**E-54 Regional Lift Station - RFCSP
Solicitation Number: CO-00537
Job No.: 22-2502**

**ADDENDUM 2
October 25, 2022**

10 **GATE POST - GROUNDING**
N.T.S.

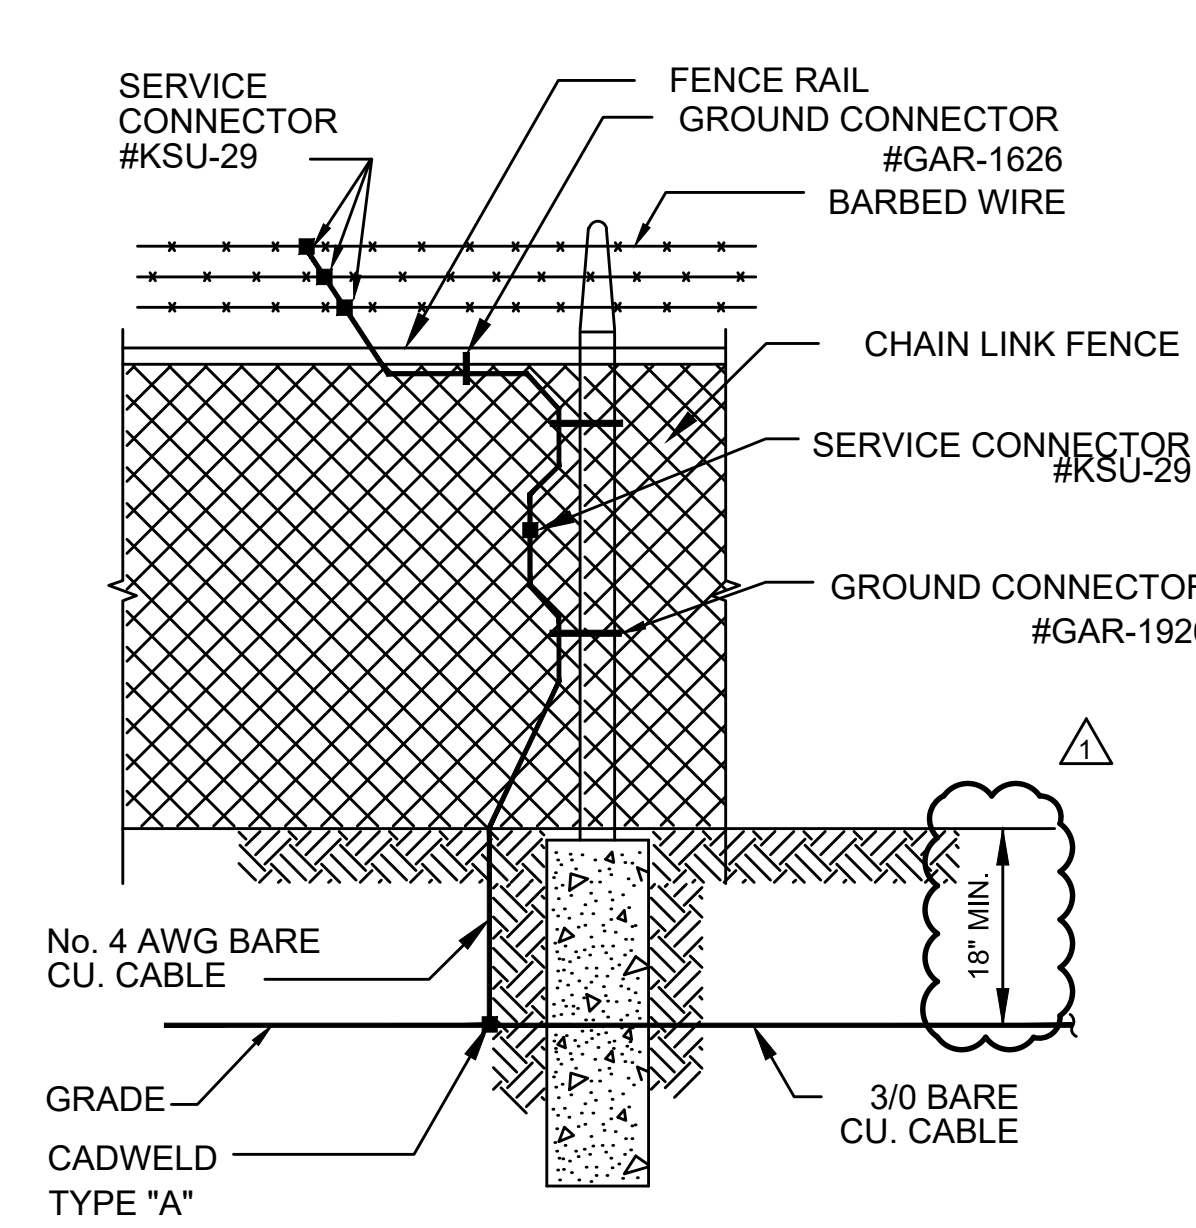
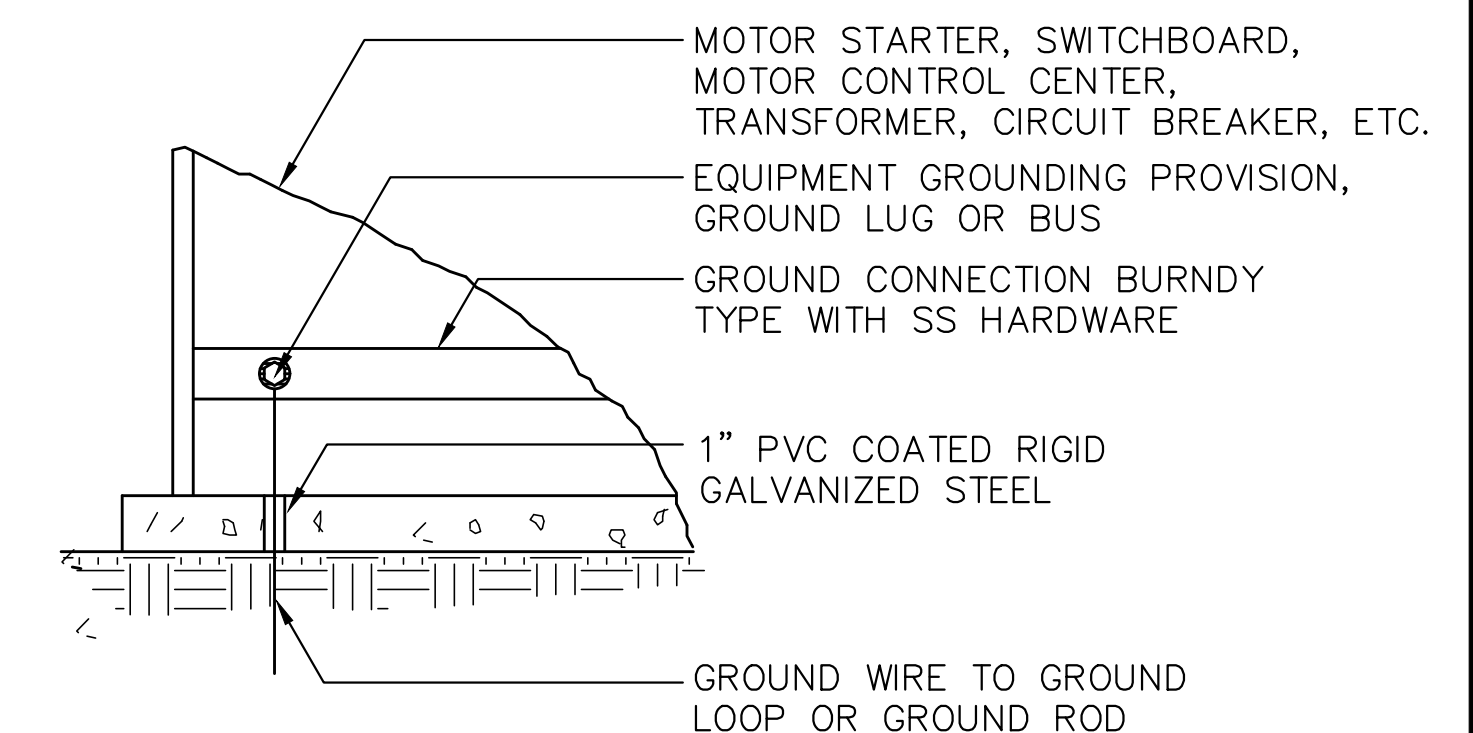
Specification Section 11500 3.4 A through D specifies Fence Grounding requirements regarding the installation, bonding methods, and intervals, however, plan sheet E4.00 shows grounding around the complete perimeter of the site with majority of Cad-weld connections on the east half of the project site. Details 9 & 10 on Sheet E11.00 shows details of the gate & fence post grounding but does not address the intervals. Detail 9 & 10 on E11.00 shows ground cables installed 3'-0" below grade; requiring rock saw cutting for the ground cable trenches. Note detail 3 on E11.00 allows ground grid to be minimum of 18" below grade. Please review and advise which details are to be utilized for the project.

RESPONSE: Sheet E11.00, details 9 and 10 revised to an 18 inch minimum ground conductor burial depth. Detail 10 revised to show fence grounding installed at 100 foot intervals. See Changes to the Plans #14.

I ELECTRICAL BUILDING LIGHTING AND AREA LIGHTING CONTROL DIAGRAMS
SCALE: N.T.S.

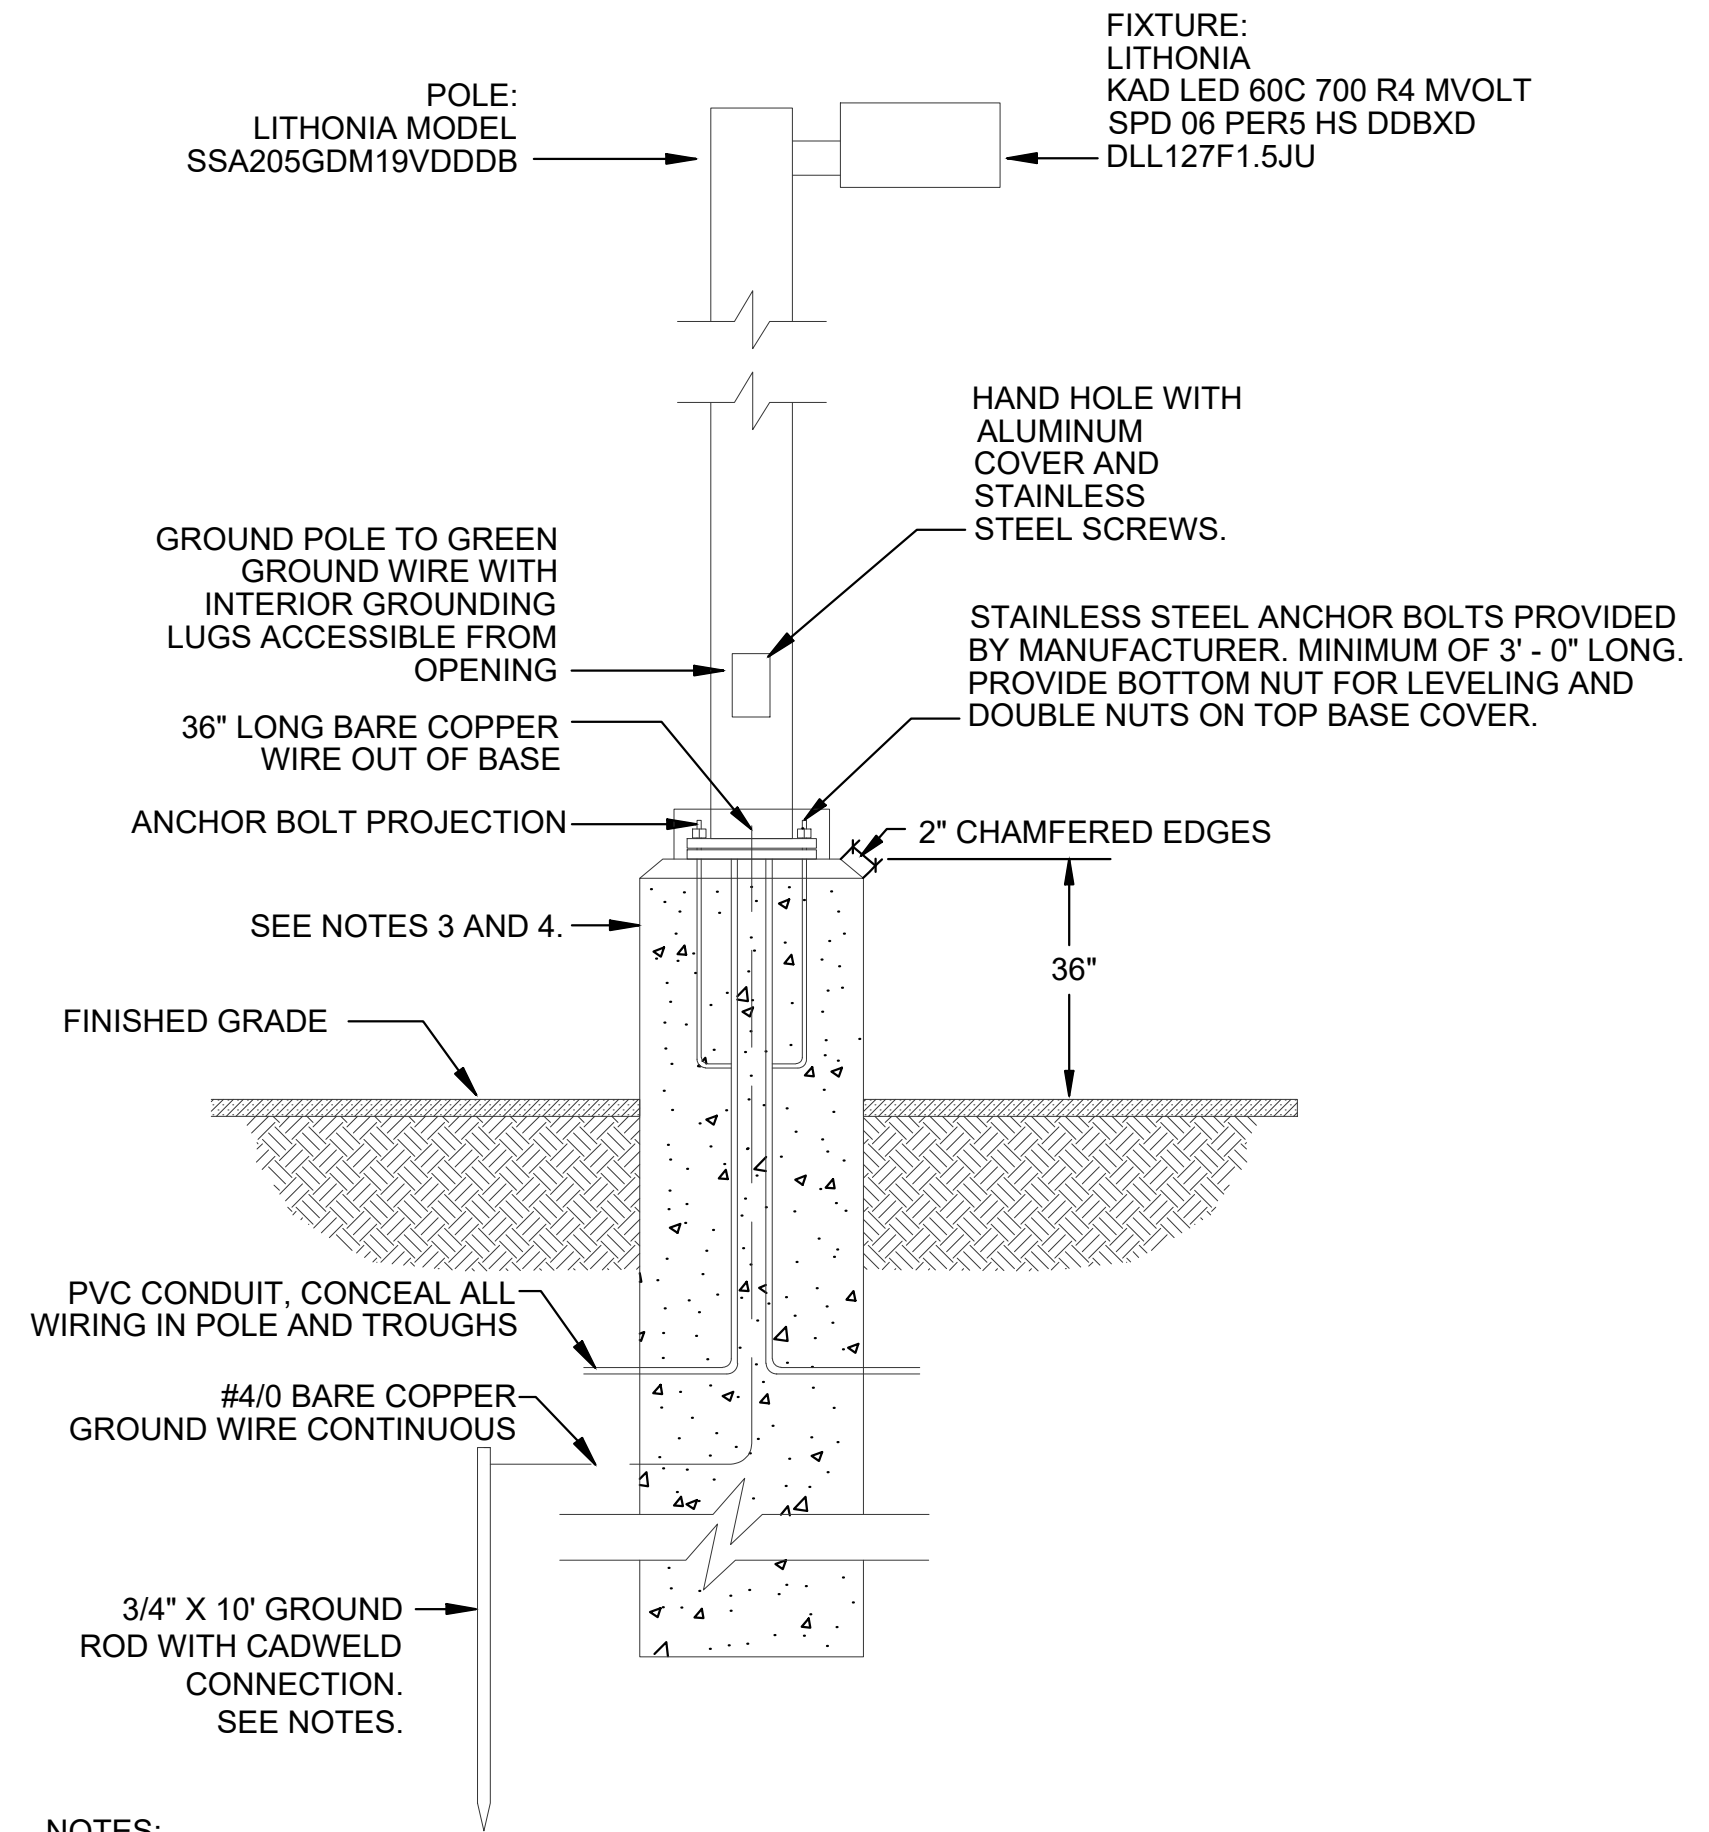
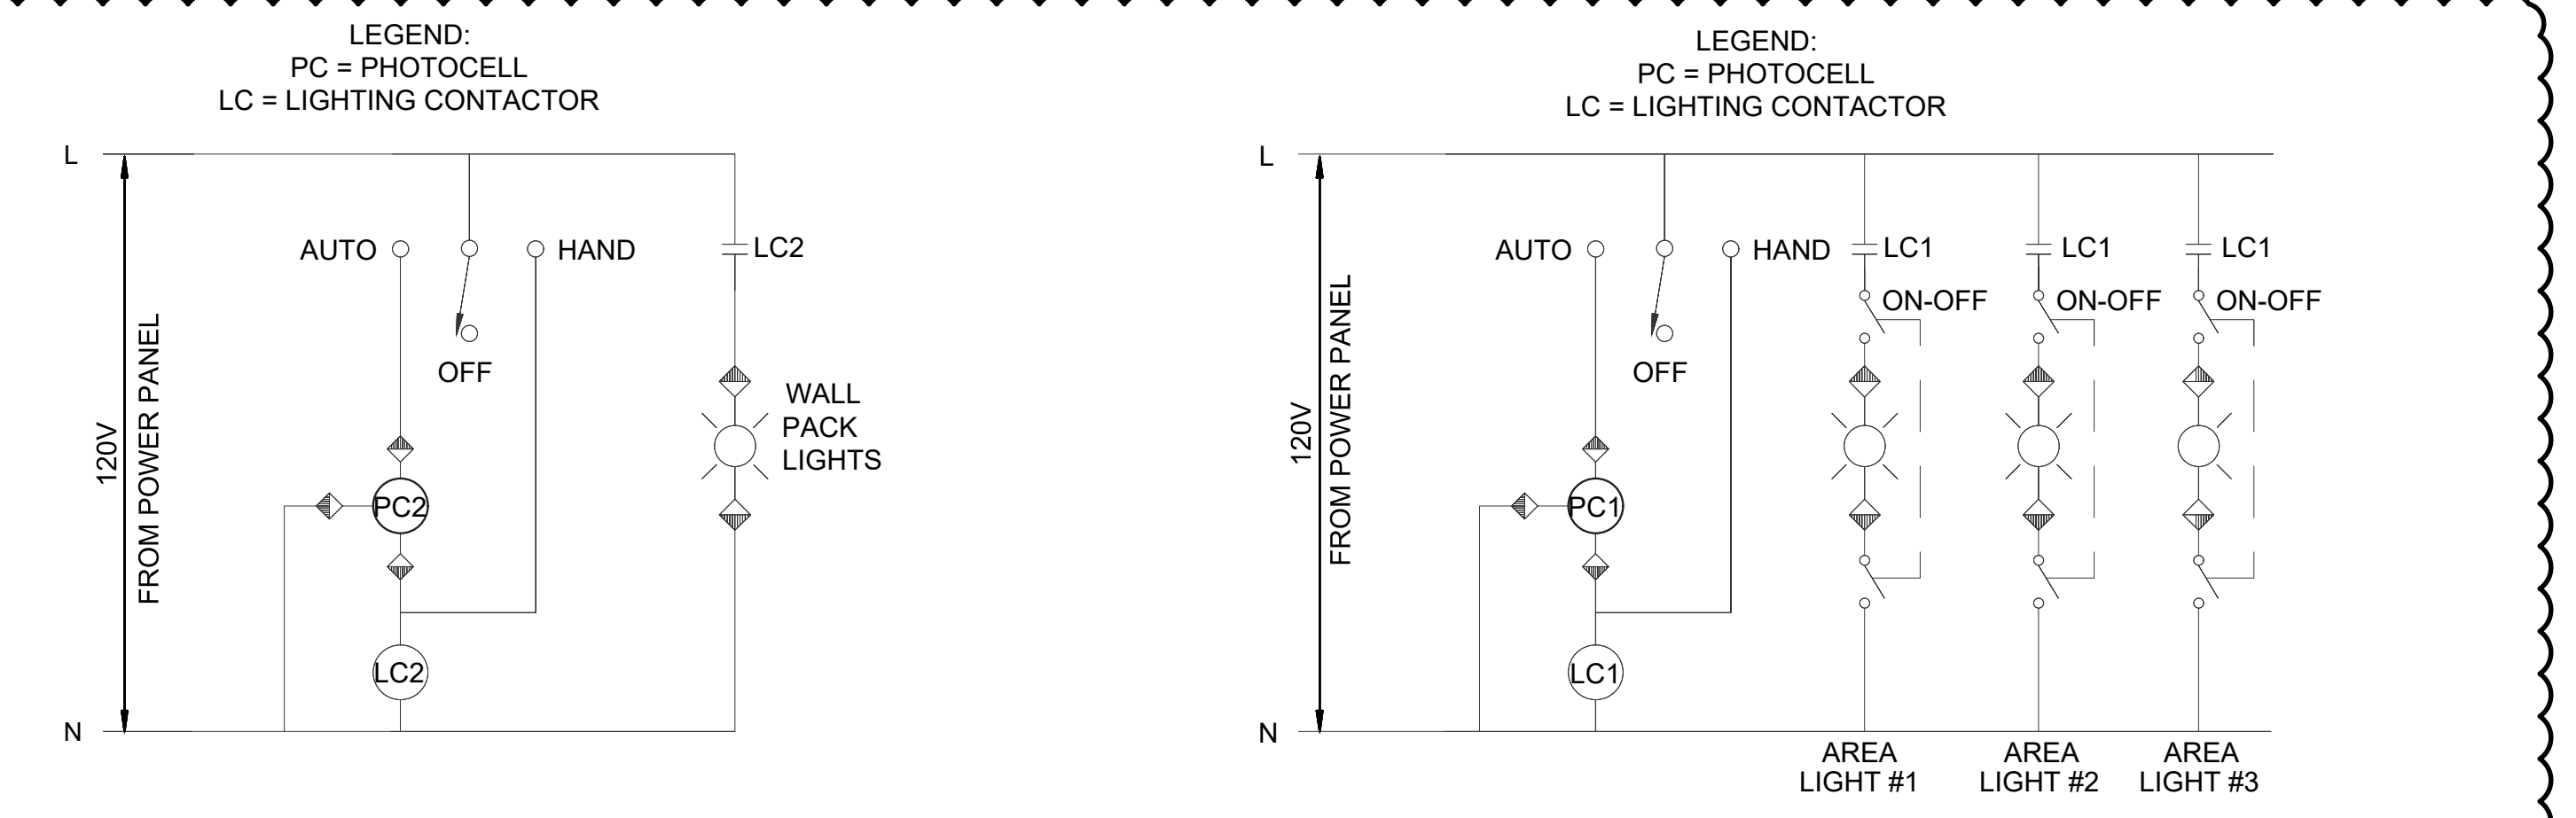
Lighting Plan Sheet E10.10 shows 2 fixtures outside of the electrical building, please confirm that those are the only exterior fixtures required as control Schematic Detail I on Sheet E11.07 shows to have a total of (4) fixtures.

Site plan shows total of (3) area light poles, control schematic on Sheet E11.07 Detail J only shows 2. Please confirm which is correct.

Plan drawing E10.00 show (1) Lighting Control Panel in the electrical building keynote #10, shouldn't detail I and detail J on Sheet E11.07 be combined into a single lighting control panel? Please confirm and revise the Control Schematic.

RESPONSE: Sheet E11.07 details I and J combined to show 1 lighting control schematic. The schematic shows 2 circuits, one controlling electrical building lighting and the other controlling area lighting. There are 2 building mounted exterior lights and 3 area lights. Sheet 11.07, detail B revised to read area light instead of yard light. See Changes to the Plans #15.
